Stakeholder Comments - Energy Imbalance Market 3rd Revised Straw Proposal

3. Protections should be Implemented to Mitigate the Problem of Base Schedule in One BAA Causing Congestion in Another BAA

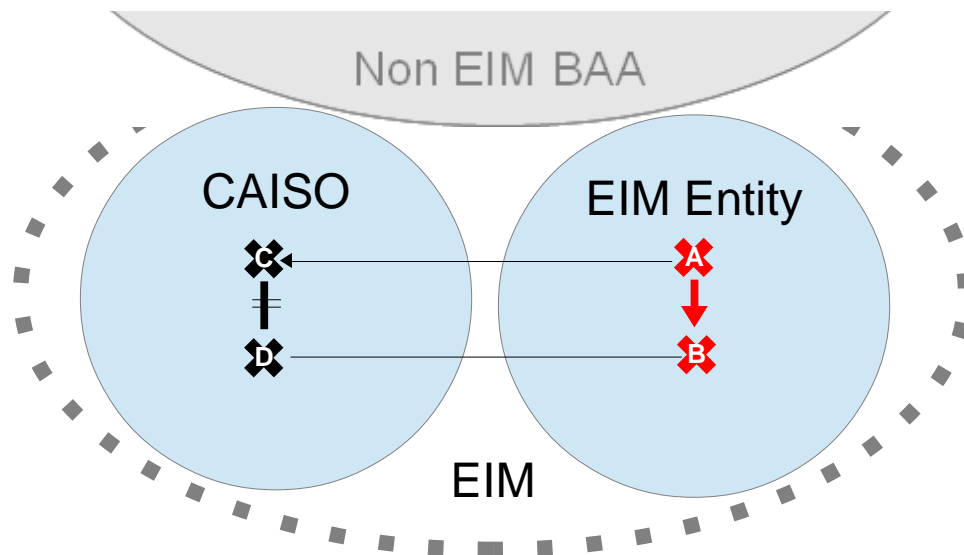
The current proposal would allocate Real Time Congestion Offset (RTCO) costs incurred to eliminate a constraint violation caused by CAISO's Day-Ahead schedules and EIM Entities' base schedules back to the BAA where the violated constraint lies. There are situations where schedules from one BAA may contribute to flow on a constraint that is inside another BAA, possibly causing a violation of the constraint that must then be managed by the EIM. Participants outside of the BAA where a constraint violation occurs may be paid to adjust their Day-Ahead or base schedules in order to alleviate flow on the binding constraint contributing to RTCO. Meanwhile, under the current proposal, the entire RTCO uplift costs needed to fund the adjustment in Day-Ahead or base schedules are borne by the EIM Entity where the constraint lies.

This may induce participants in some BAAs to over-schedule at certain nodes or change their scheduling practices and benefit from imbalance revenues that will be funded in part by RTCO costs charged to participants in other BAAs. In particular, some entities may find it profitable to over-schedule supply and load in their base schedules so that they will be paid to remove the over-schedules in EIM. To reduce the incentives to engage in such practices, PG&E recommends putting over-scheduling penalties in place. Such over-scheduling penalties were part of the original EIM proposal; the CAISO later removed them in the 2nd revised straw in light of the currently proposed RTCO allocation method. However, as discussed in this section, these penalties are still needed because base schedules within one BAA can cause congestion, and potentially drive up RTCO costs in another BAA.

The 2nd Revised Straw Proposal eliminated the original over-scheduling penalty because analysis showed it would be ineffective, and while examples like PG&E's have not appeared to be likely in the near-term EIM implementation, the ISO committed to monitoring such behavior and implementing changes in EIM design if issues appeared. Nevertheless, to ensure that EIM provides protections that stakeholders feel are needed, the Draft Final Proposal includes an
